FLA COE
FLB COE
> FLD Conventional
Business Class

Freightliner
Service Bulletin

Vehicles equipped with DDEC IV have a relative-humidity-sensor wiring harness. On many vehicles this harness is routed too close to the exhaust tubing, which can result in heat damage to the wiring. This harness must be rerouted, and if damaged, replaced. Follow the instructions under "Procedure," below.

Fig. 1, Heat-Damaged Harness

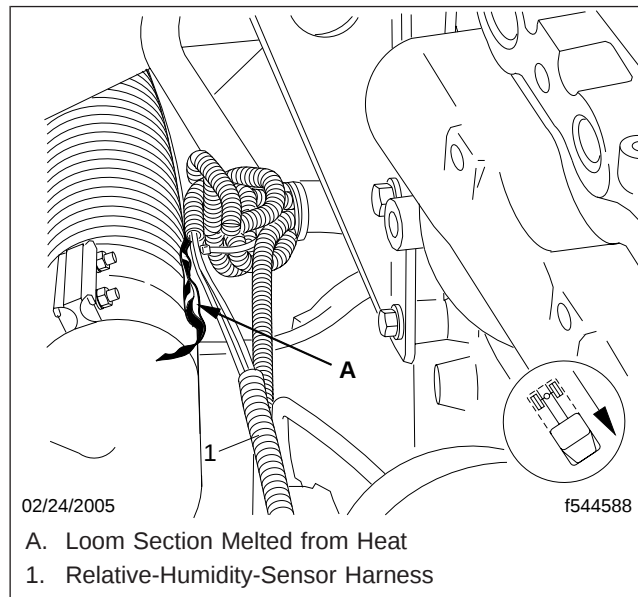
3. For Argosy vehicles, tilt the cab.
For all other vehicles, tilt the hood.
4. Find the relative-humidity sensor and its wiring harness on the air intake tubing. Check for heat damage from the exhaust. See [Fig. 1](#).

If there is any heat damage, install a new harness and reroute it, as instructed in the next step.

If the harness is not damaged, reroute it, as instructed in the next step.

Fig. 2, Relative-Humidity-Sensor Harness (typical routing)

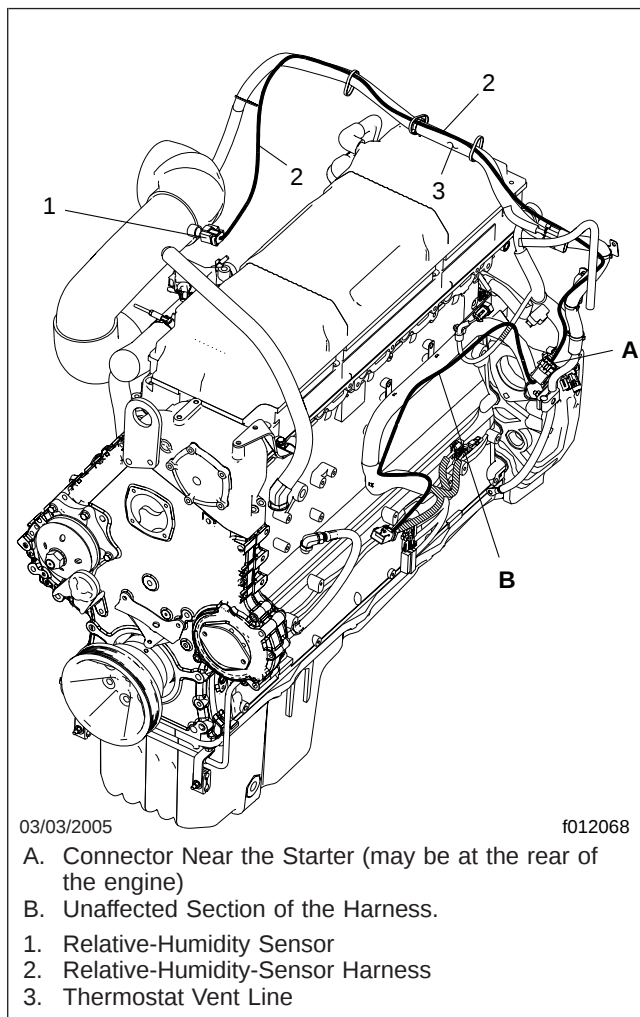
5. Reroute/replace the relative-humidity-sensor harness. See [Fig. 2](#).

5.1 Remove the splash shields from both front fenders.

5.2 Disconnect the harness from the sensor on the air intake tubing.

Fig. 3, View From the Rear of the Engine

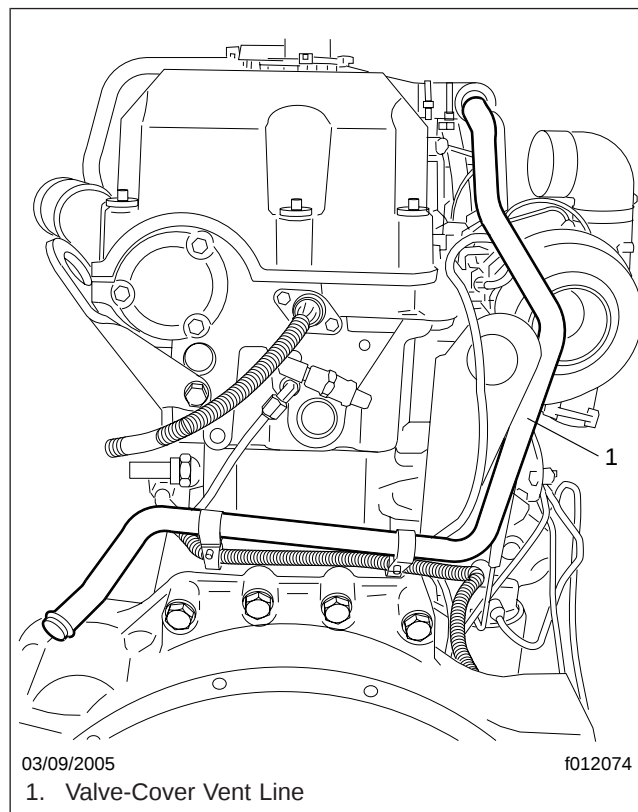
- 5.3 Remove the tie straps that hold the harness to the valve-cover vent tube. See [Fig. 3](#).

Pull the harness out to the driver's side of the engine compartment. If replacing the harness, disconnect it from the second connector at the rear of the engine (or near the starter).

Fig. 4, Harness Rerouted

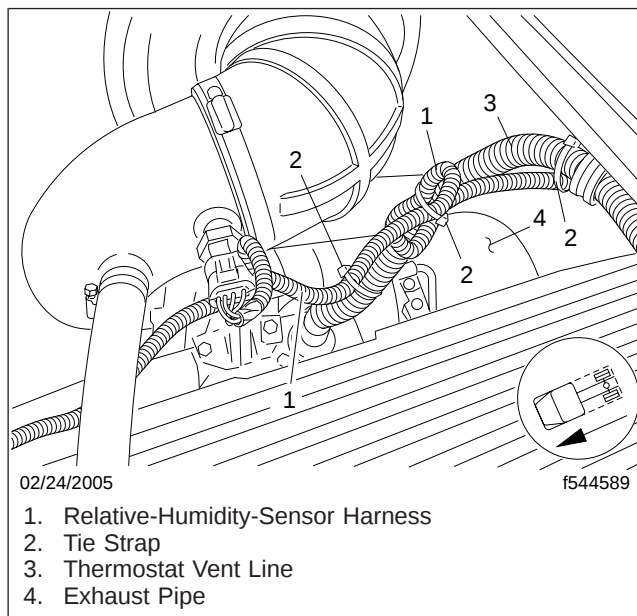
5.4 If replacing the harness, attach the end of the new harness to the connector at the rear of the engine (or near the starter). Route the harness (new or existing) along the top of the cowl, and secure it to the thermostat vent line with tie straps. If necessary, coil the harness to take up any slack. See [Fig. 4](#).
